**ADDENDUM NO. 2**

**CONTRACT NO. PH4 2010-01  
FOR CONSTRUCTION OF**

**TRLIA PHASE 4  
YUBA RIVER SOUTH LEVEE  
UPPER YUBA LEVEE IMPROVEMENT PROJECT  
PLM 2.2 TO 6.1/STA 102+00 TO 303+59**

**July 30, 2010**

COVER SHEET		
FILENAME	00G-000.dwg	SHEET
SCALE	NONE	G-000

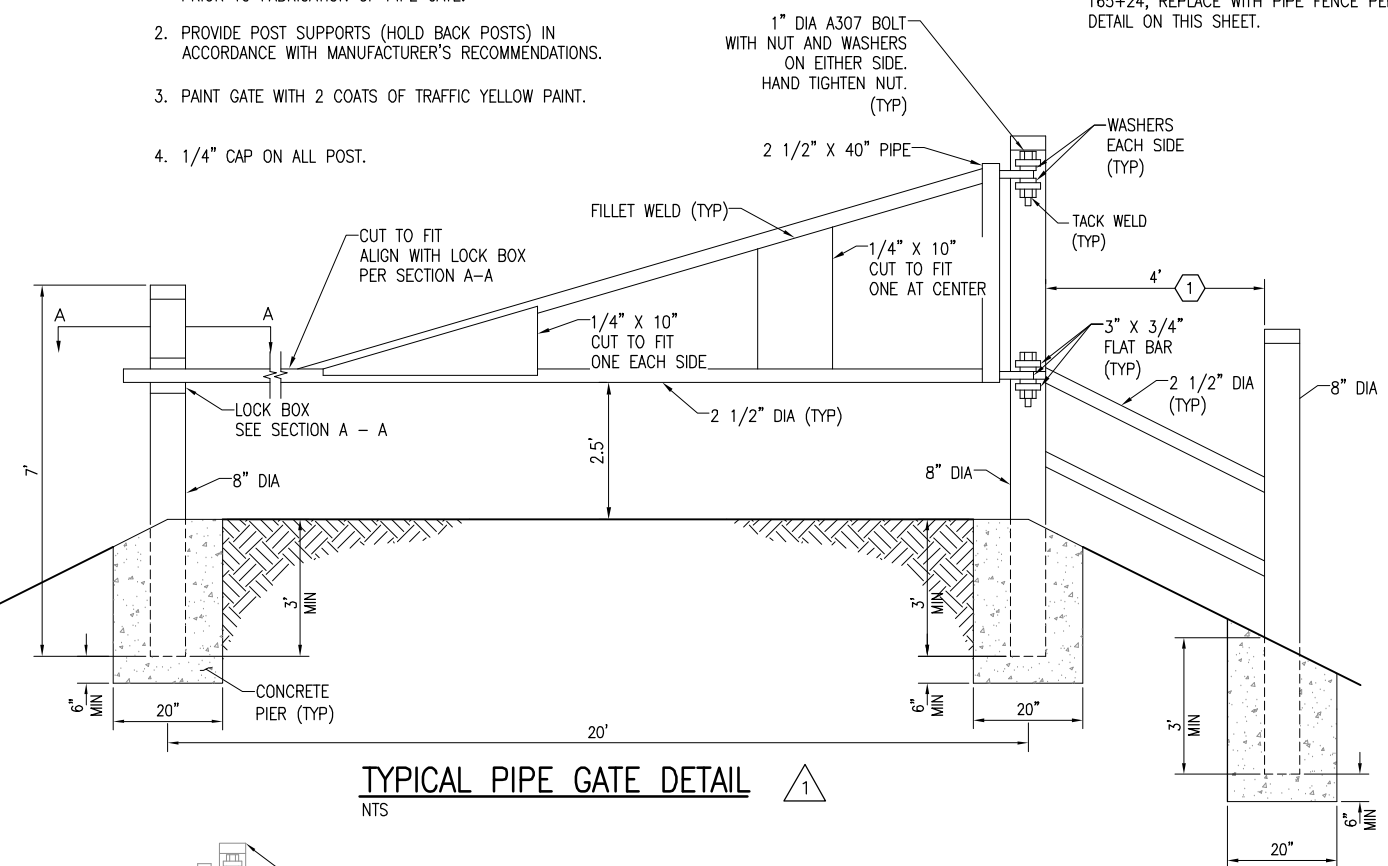
**Replace the following sheets:**

G-000  
C-328
